PRODUCT CHANGE ANNOUNCEMENT

Marathon Special Products is announcing a change in the design of the 142 series power blocks. This product change is the result of a tooling modification intended to reduce molding maintenance costs and downtime and provide more valued features.

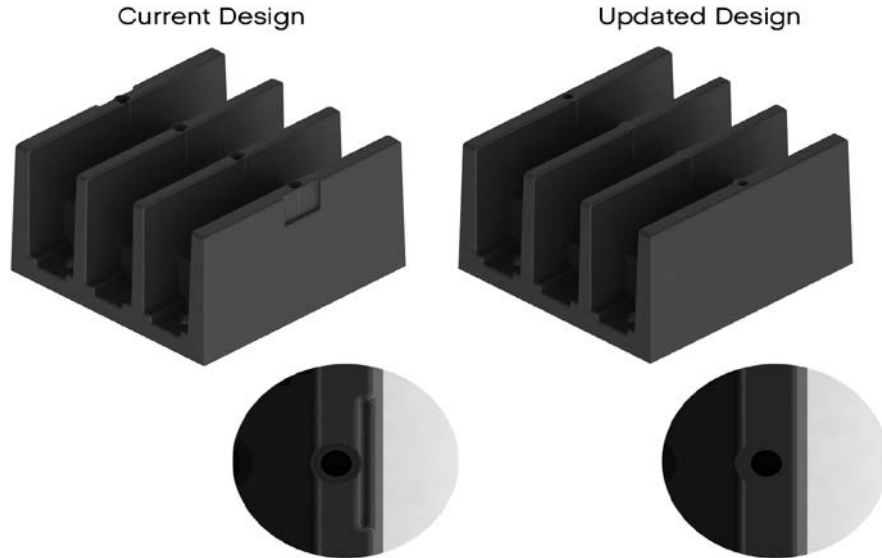
1. Eliminated all non-functional center holes on the top of the power block interior barriers.
 - o These holes had no intended function and were not promoted as a design feature of these power blocks. Some utilized them to mount marking strips where they provided a more robust surface area as opposed to the outside top barrier holes, which we have addressed in this design upgrade.

- o Elimination of unnecessary locator pins in the mold will improve production efficiency by minimizing mold maintenance and downtime.
2. Removed non-functional reliefs on exterior barriers.

- o Cosmetic feature only, pictured below as item 2
 - o Additional material around the end mounting holes for covers and marking strips provides a stronger mounting which minimizes risk of breakage while fastening down covers or marker strips.

3. Increased the center-to-center hole dimensions (A) Item 3 pictured below by .040" (from 2.436" to 2.476").
 - o In conjunction with Item 2 above, mounting holes in the exterior barriers have been centered in those barriers. This repositioning results in the increased center-to-center hole dimension providing greater strength and product integrity.

4. Marker strip slot dimension "B" Item 4 below, will be increased by 0.010" which will accommodate the increased dimensional changes in the blocks center-to-center hole addressed in Item 3.
